NUMBER
DEP16243

SOLICITATION NUMBER: DEP16243
Addendum Number: 1

Orgas Keith Portals

Addendum #1

UNDERDRAIN CONVEYANCE PIPES
ILLUSTRATION FOR LOCATION
PURPOSES ONLY

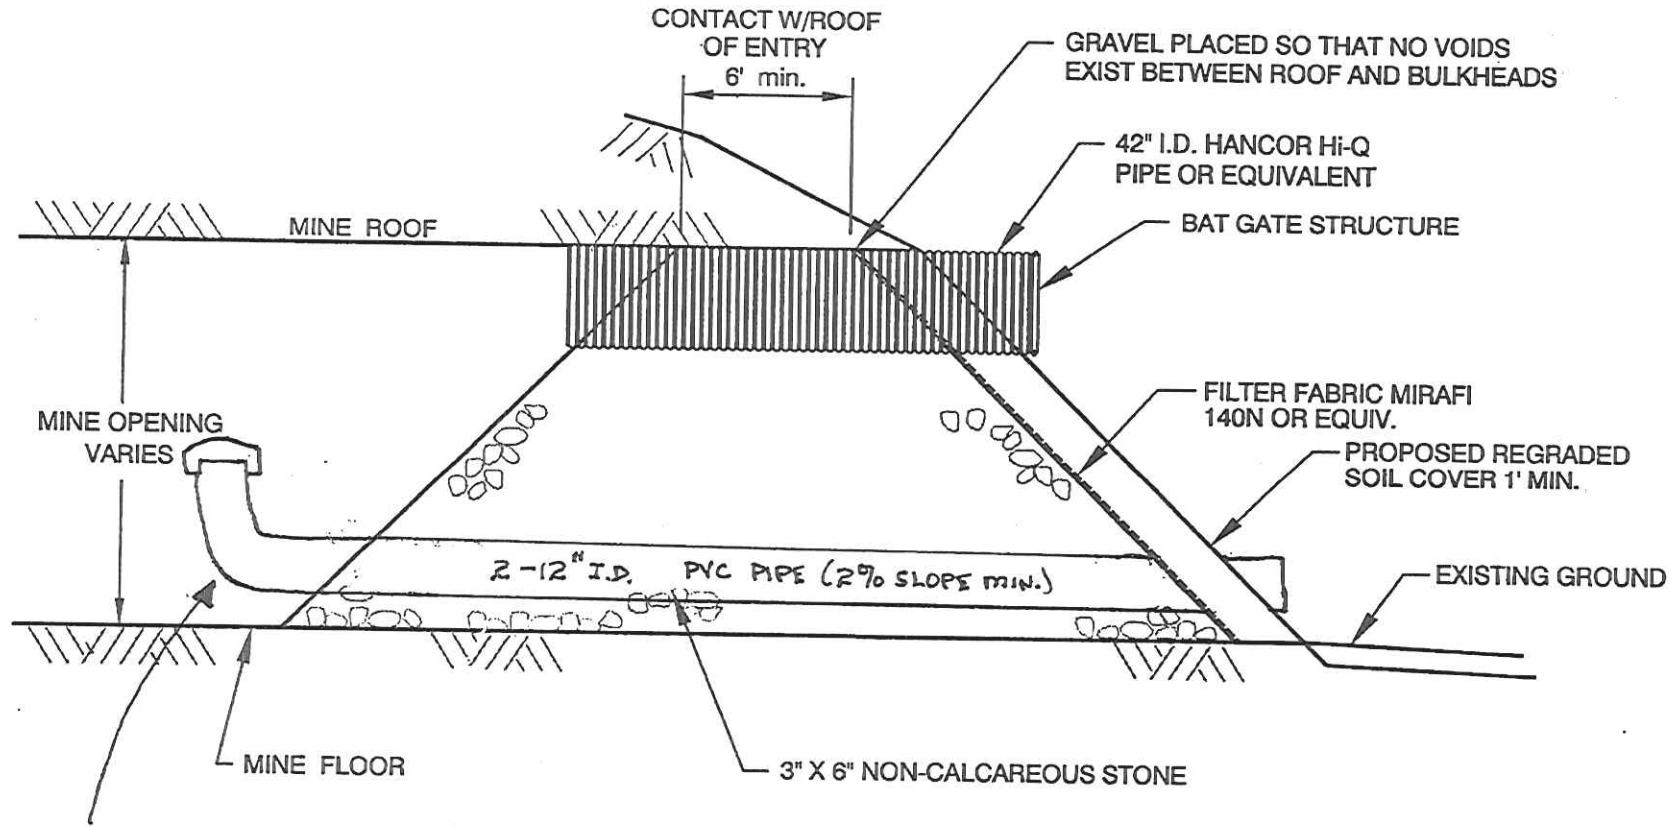
- A. The Contractor will have 120 days from the date of the Notice to Proceed to complete construction activities on the project. The \$250 per day liquidated damages clause will be in effect after the 120 days. However, the total performance period will be 365 days from the date of the Notice to Proceed for invoicing purposes.
- B. On sheet 13, on the Front View of the Bat Gate seal, the underdrain pipes are shown. On the Side View, they are not shown. They should be shown, and a drawing is attached illustrating the location of the underdrain pipes.
- C. Water Levels and water quality test results are as follows.
